Restroom Air Outlets - Breakdown by Floor

Clouded areas on M-529 / M-530 / M-531 (re-issued 10/14/2026) | Quantities only, pricing to follow

30-3 Food Prep / Holding 30.12B: Combination fire/smoke damper 24x8 with duct access door at rated wall on existing 24x8 supply duct (FPB-D (750) to A (750))

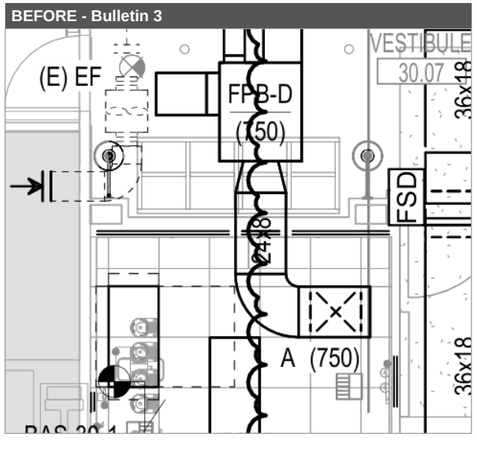
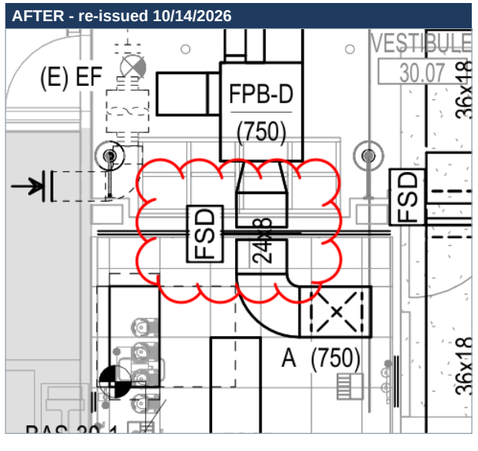
4. 30th floor only: combination fire/smoke damper with duct access door on the existing 24x8 at the Food Prep / Holding 30.12B wall (FSD added in the cloud).
